# Working Group - C57.104 IEEE Guide for the Interpretation of Gases Generated in Mineral Oil-Immersed Transformers

IEEE/PES Transformers Committee  
Spring 2025 Meeting

Meeting # 2

Figure D.3—Duval Triangle 4 method for low temperature faults

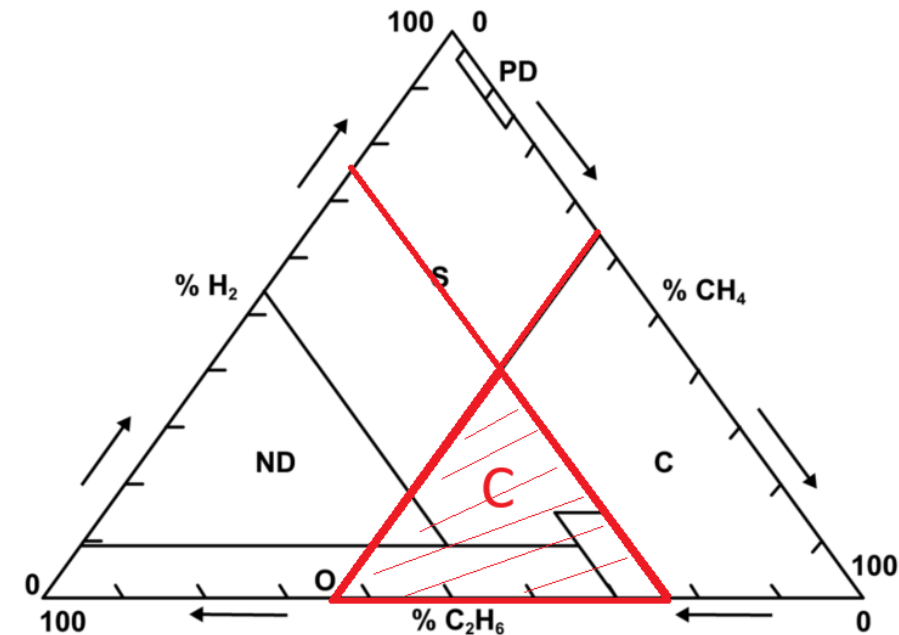
- Topic: Mistakes in Duval triangle 4 & 5
- C57.104-2019 contains mistakes in how Duval triangles 4 & 5 are defined, as compared to the **source material excel file** in C57.104-2019 downloads.zip

- Topic: Mistakes in Duval triangle 4 & 5
- Example 1

- Topic: Mistakes in Duval triangle 4 & 5
- Proposal to fix the mistakes

Triangle 4 changes:

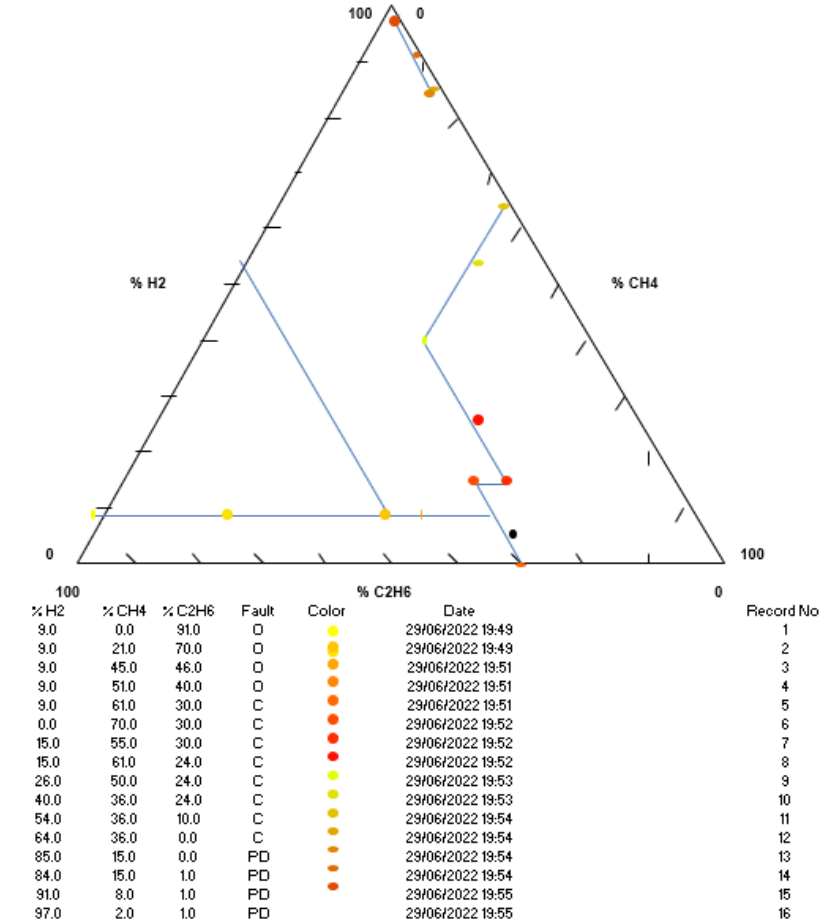
- Topic: Mistakes in Duval triangle 4 & 5
- Example 2

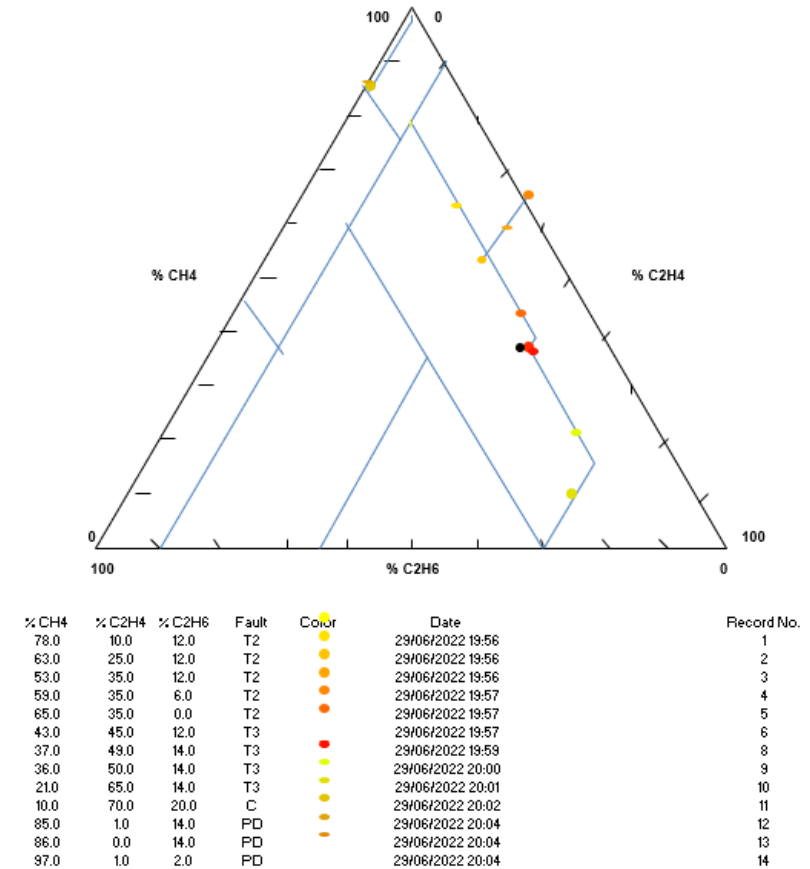
- Topic: Mistakes in Duval triangle 4 & 5
- Example 3

Triangle 5 changes:

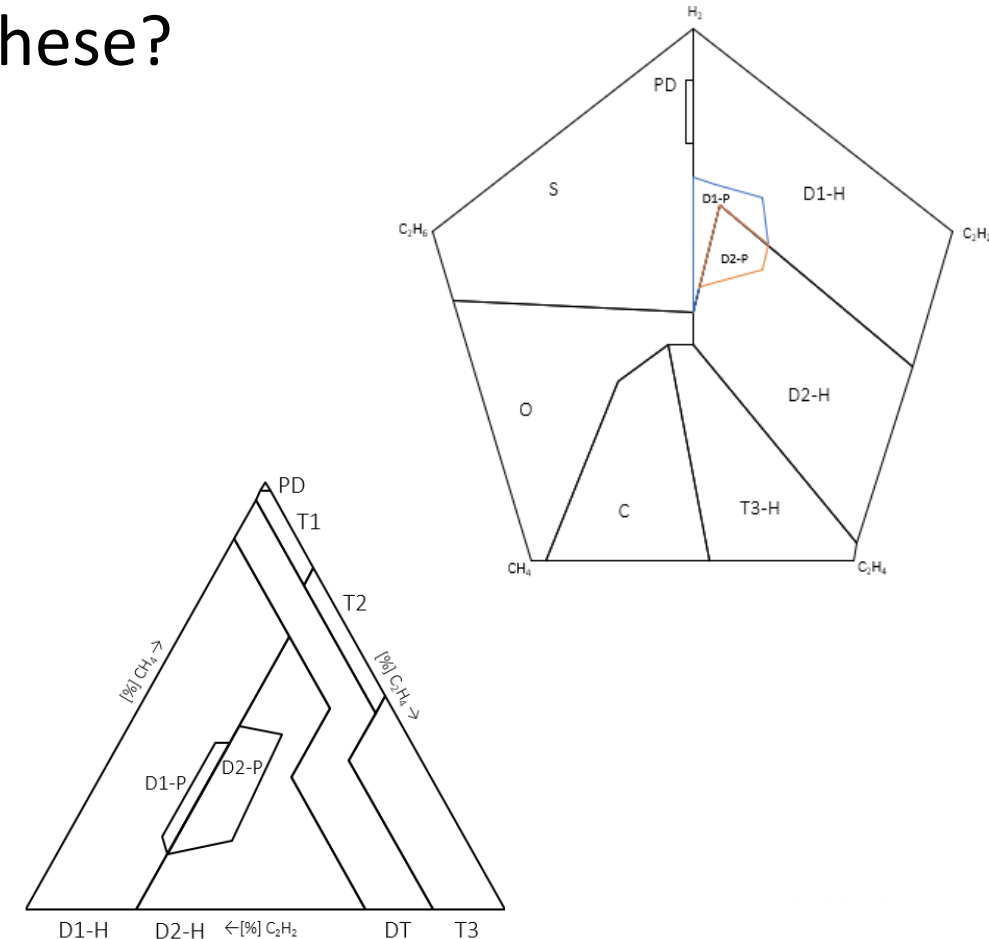
- Topic: Corrections to Duval pentagons 1 & 2 and arcing sub-faults of
- Small corrections were discussed in IEC 60599 maintenance group to Duval pentagons 1 & 2 to correct for potential graphical errors especially in the edges of the zones
- Adding distinction between arcing sub-fault types of discharges in oil (-H) and in paper (-P) is under consideration for Pentagon 2 (b) and Triangle 1 (b)

- Topic: Corrections to Duval pentagons 1 & 2 and arcing sub-faults of
- The WG could consider the applicability of these?

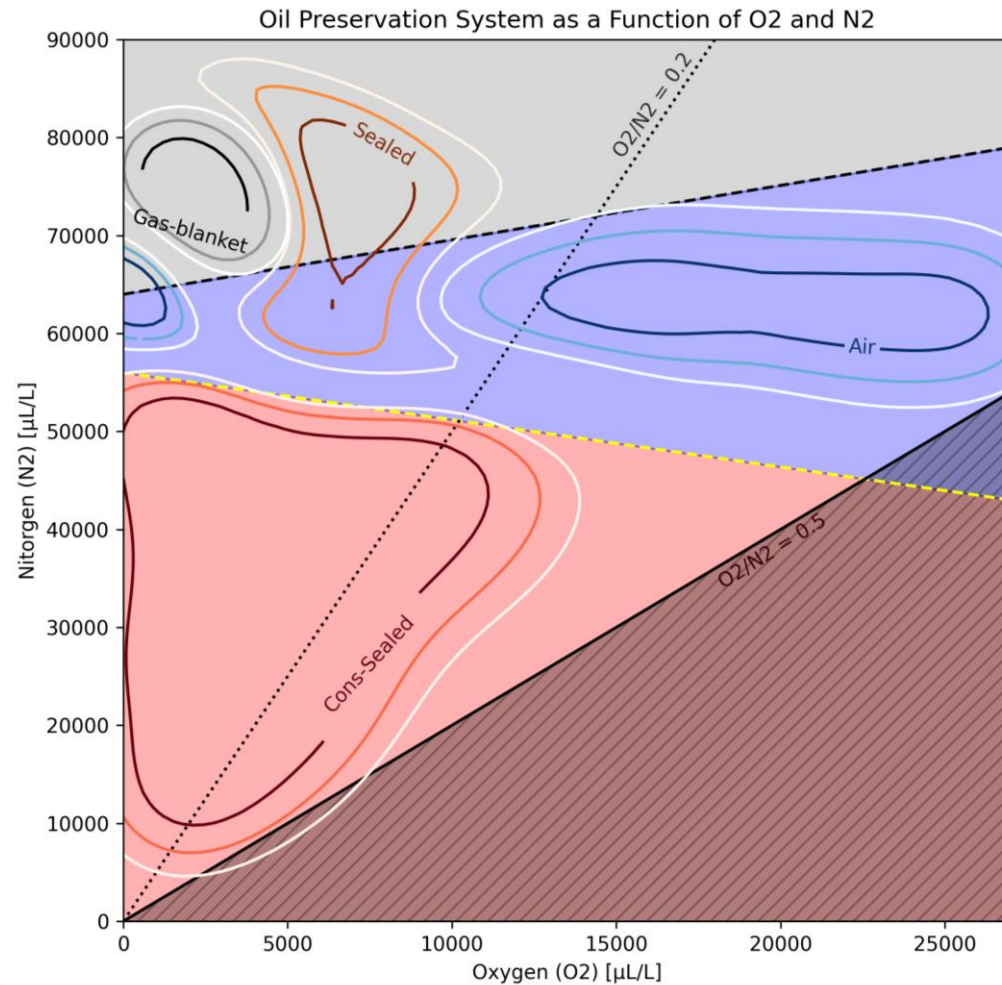
- Topic: Oil Preservation types
- O<sub>2</sub> & N<sub>2</sub> clearly affects the DGA statistics. But the association of O<sub>2</sub> & N<sub>2</sub> gas concentrations or ratios with the actual oil preservation type is somewhat weak (due to lack of data).
- To address the problem, we need an industry guideline for how to classify major classes of oil preservation systems (similar to cooling systems or LTCs) to properly categorize the DGA data. Future revisions of C57.104 will hopefully benefit from data being more clearly labeled by using such a scheme.
- Even if we manage to collect the current data available, no guidance has been given as to what certain common terms actually mean, hence data is often mis-classified (e.g. “Gas-Sealed” vs “Gas-Blanket”) or under-classified (just “Conservator”).

# A Proposed Classification Scheme

For example: **AD** = air breathing with desiccant, **CBN** = Conservator with a bladder, no desiccant, **CFD** = Conservator, free-breathing with desiccant
